CITY OF KELOWNA
MEMORANDUM

APPLICATION NO. DP08-0234

AT: 2955 Pandosy Street

PURPOSE: TO APPROVE A DEVELOPMENT PERMIT FOR THE FORM AND CHARACTER OF THE PROPOSED 4 STOREY, 39-UNIT MIXED-USE SUPPORTIVE HOUSING BUILDING

1 SITE PLAN
SCALE: 1/8" = 1'-0"

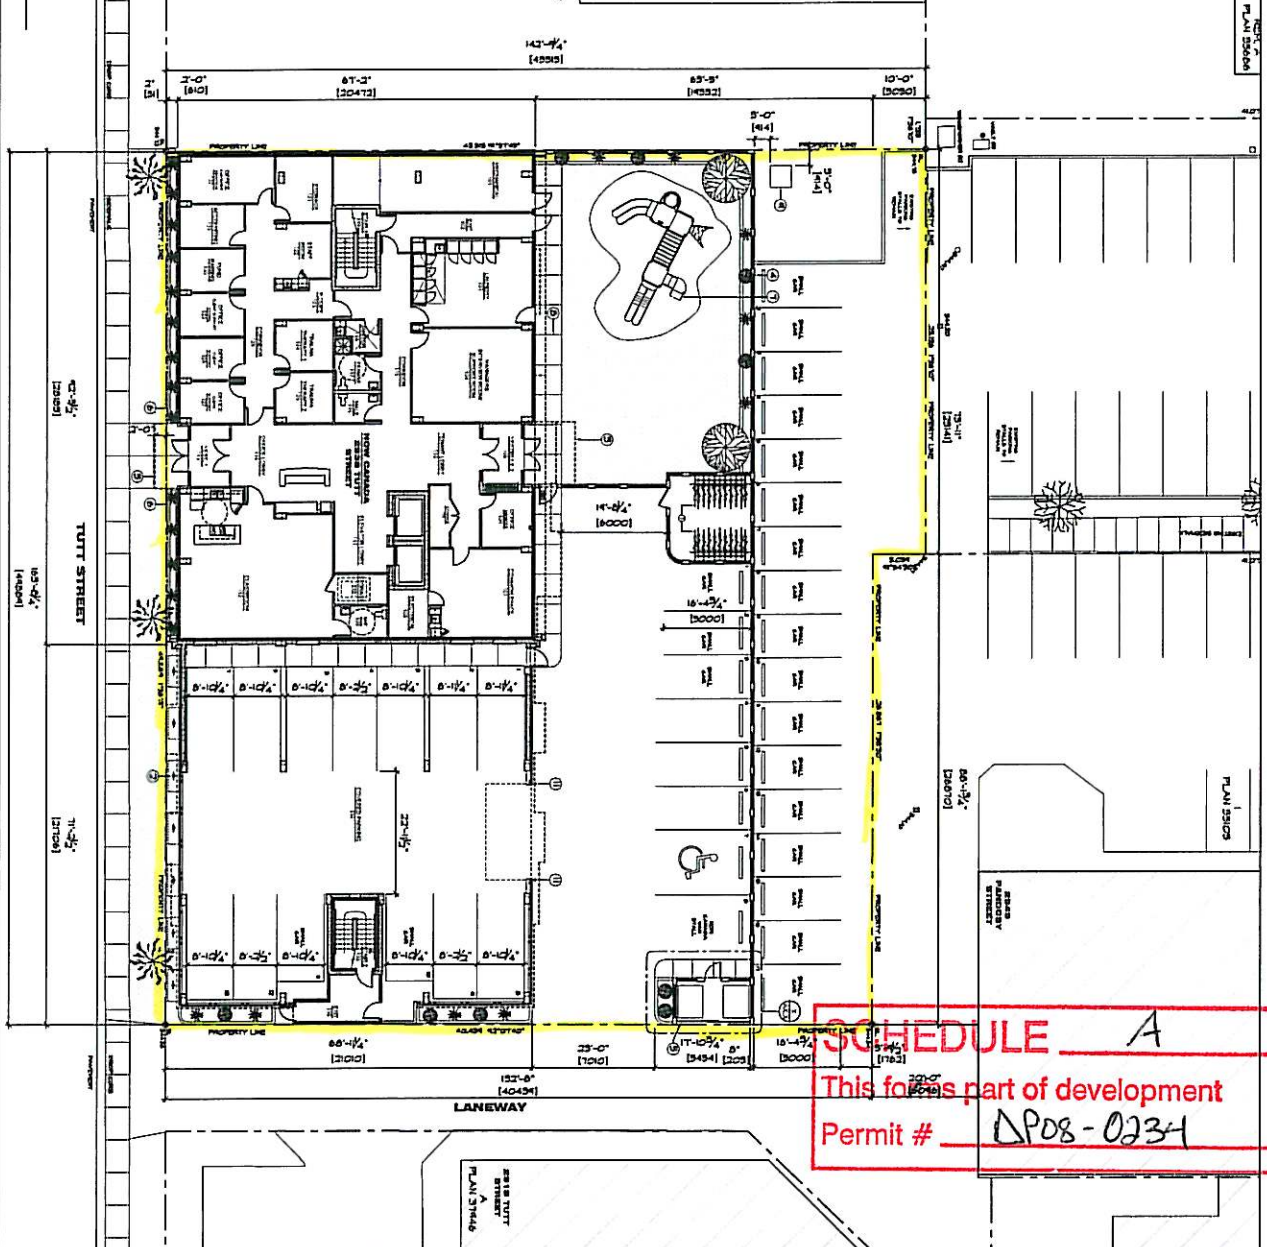
- (a) The site plan should illustrate the ability of vehicles to manoeuvre onto and off the site without requiring a reverse movement onto public roadways. If the development plan intends to accommodate larger vehicles, the site plan should be modified and illustrated accordingly.
- (b) A revised site access and egress design onto Pandosy Street and Tutt Street as well as the parking lot configuration must be submitted for approval by the City before issuance of a development Permit. This is required to guarantee that the requirements and the limitations of access and egress required by the City have been addressed to the City's satisfaction.

1
FRONT ELEVATION - EAST
 SCALE: 1/8" = 1'-0"

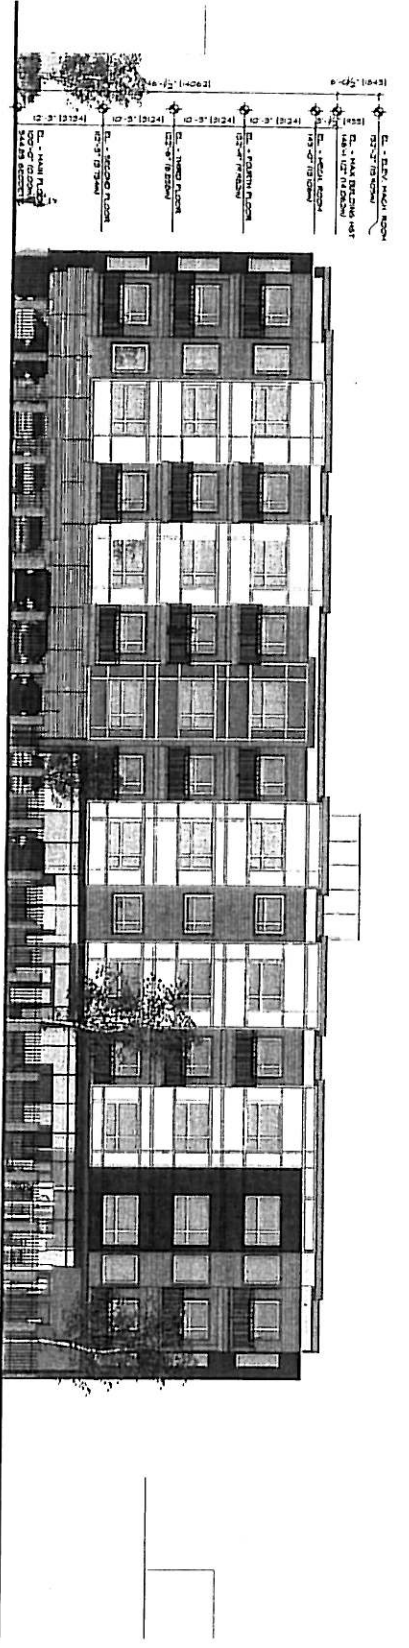
Door from stair shaft from residential floors (south elevation) to exit corridor to swing in direction of exit travel. Exit stair shaft from residential floors (north elevation) located in parkade must exit directly to exterior of building at laneway.
